REPORT TO THE SUBDIVISION AND
DEVELOPMENT APPEAL BOARD

DATE: January 13, 2022	APPEAL NO.: SDAB 2021-0091 FILE NO.: DP2020-7757
APPEAL(S) BY: Ryder McRitchie, Bill Overend, Alif Noorani, and Chris Wong	
FROM A DECISION OF THE DEVELOPMENT AUTHORITY where a New: Dwelling Unit, Retail and Consumer Service was approved at <u>218 19 Street NW</u>	LAND USE DESIGNATION: MU-1 f3.3h19 Discretionary
COMMUNITY OF: West Hillhurst	DATE OF DECISION: December 1, 2021
APPLICANT(S): Formed Alliance Architecture Studio	OWNER(S): Hillhurst Boutique Ltd. Represented by Rick Grol

Online Store Information			
Confirmation Number 10399066	Order Number 37150172	Online Form Processed 2021-12-21 11:40:13 AM	
Site Information			
Municipal Address of Site Under Appeal 218 19 ST NW		Development Permit/Subdivision Application/File Number DP2020-7757	
Appellant Information			
Name of Appellant RYDER MCRITCHIE		Agent Name (if applicable)	
Street Address (for notification purposes) 215 18A STREET NW			
City CALGARY	Province ALBERTA	Postal Code T2N 2H1	Residential Phone # 403-614-9071
Business Phone # 403-614-9071	Email Address ryder.mcritchie@gmail.com

SHADOWS - PROPOSED BUILDING
SHADOWS - EXISTING CONTEXT

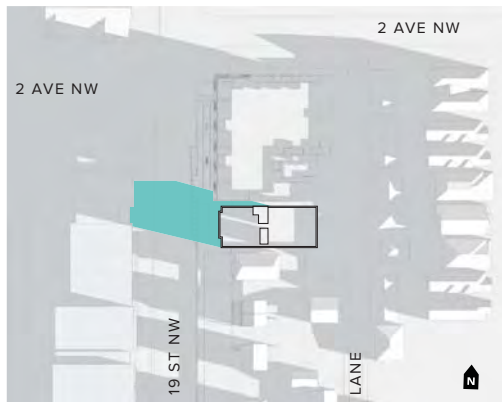
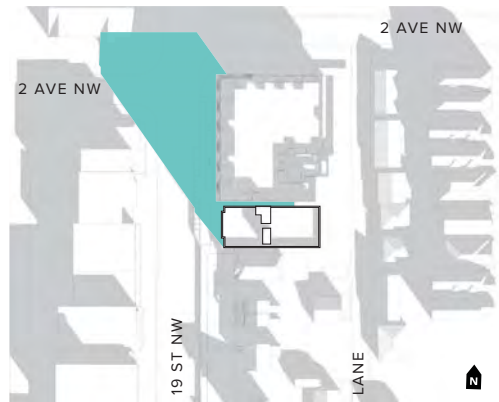
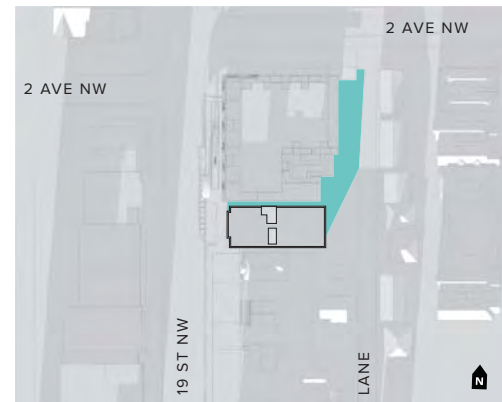
2) Lack of tiering to address shadowing of adjacent properties (boring/boxy design with 5 storey alley facing wall is inconsistent with 19+2 design and expectations conveyed for neighboring Innurskape project during City hearing);

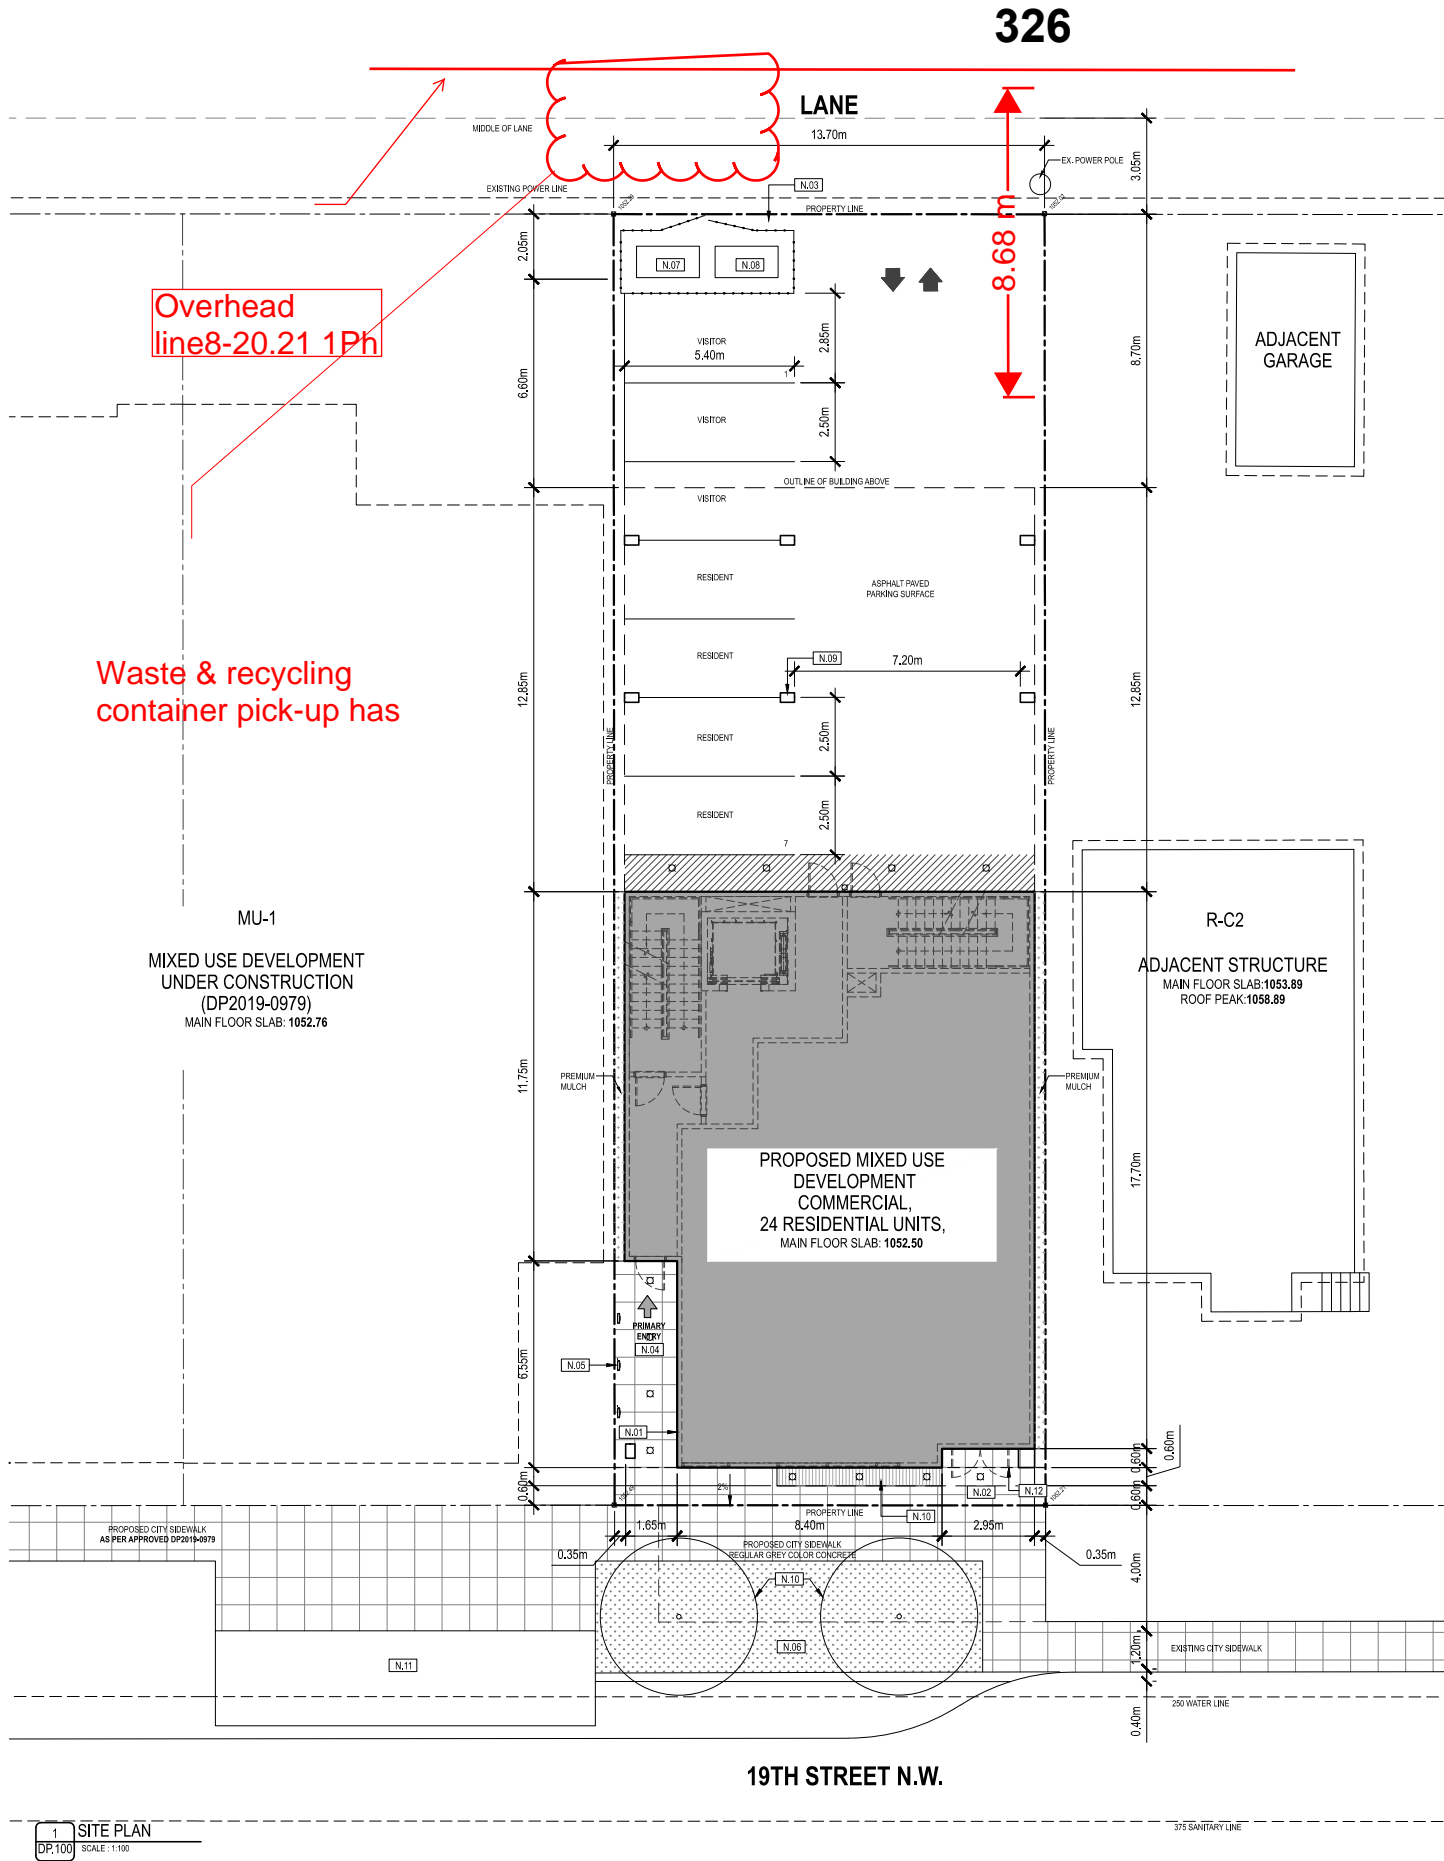
Waste & recycling container pick-up has potential conflict with overhead powerline. Any details on how truck will pick-up these containers.

Please contact Arnel Soledad at ASoledad@enmax.com or at 403-796-6268 to further discuss resolution options for this conflict.
